PLEASE FOLLOW THESE STEPS FOR COMPLETING THE NECESSARY MODIFICATIONS TO SHOCK ABSORBER BRACKETS ON NASH MODELS 24M & 29S.

THIS APPLIES ONLY TO NASH MODEL 24M  
 S/Ns 49568-49639  
 (APRIL 2018)  
 &  
 NASH MODEL 29S  
 S/Ns 49720-49779  
 (MAY 2018).

## Shock Mount Bracket Modification Steps

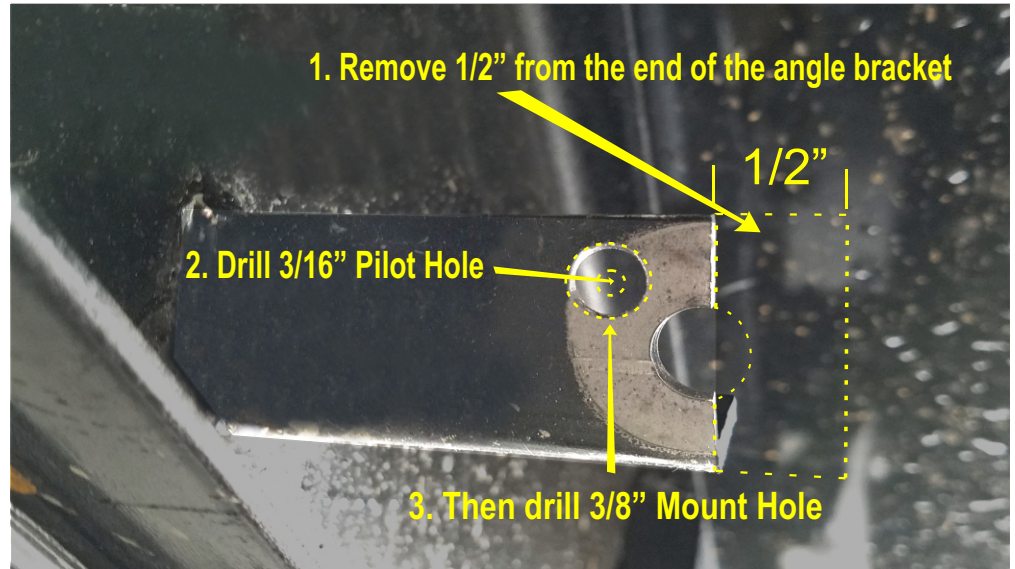
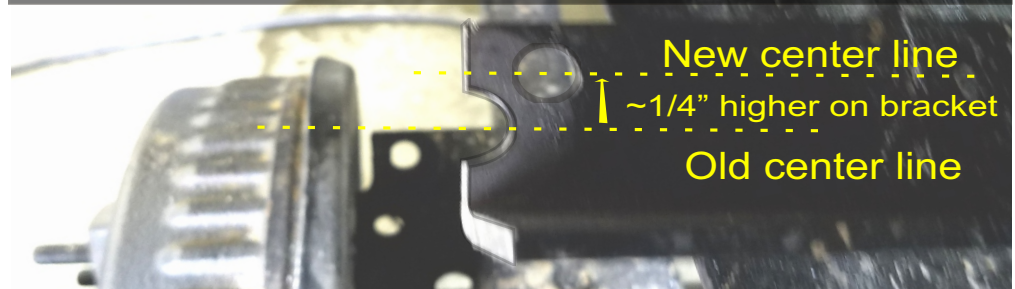
**New Hole should be centered higher than the previous hole to allow the shock mounting grommet to seat correctly.**

1. Jack up one side of trailer.
2. Remove both wheel/tire assemblies.
3. Uninstall top of shock from bracket
4. Cut 1/2" off the angle bracket  
(cut will fall appx. at the center of original hole).
5. Drill 3/16" pilot hole  
(centered ~1/4" higher than previous hole center).
6. Drill 3/8" shock mount hole.
7. Reinstall shock and tighten mounting nut.
8. Paint all exposed metal from saw cut with rust preventative paint.
9. Repeat steps 3-7 for second shock bracket.
10. Reinstall tires and torque bolts to 110 ft/lbs.
11. Repeat steps 1-10 for opposite set of shock brackets.
